Conceptual Review Agenda

Schedule for 06/16/14 to 06/16/14

Liberty Farms Single-Family Homes

Re: Liberty Farms - Single-Family Homes

SITE-PLAN

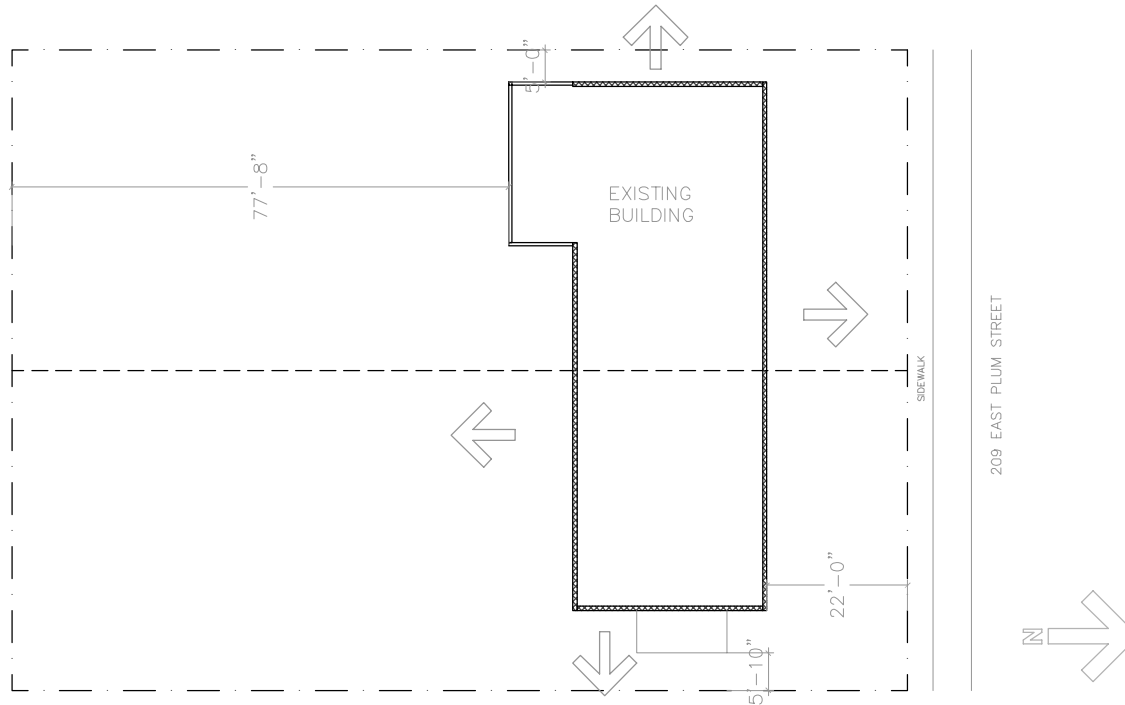
2. LOT DIMENSIONS: The Conceptual Review Application notes that the lot dimensions are 50x150. However, the County Assessor's office lists the property as 14,000 square feet in size. Please clarify the square footage of the lot, as it will affect the allowable floor area per LUC Section 4.8(D)(2).

7. PARKING: No off-street parking is currently provided. How many employees does the center currently have, and how many new employees would the addition bring? Section 3.2.2(K)(1)(h) specifies that child care centers provide a minimum of 2 off-street parking spaces per 3 employees or 1 parking space per 1,000 square feet of floor area, whichever is greater.
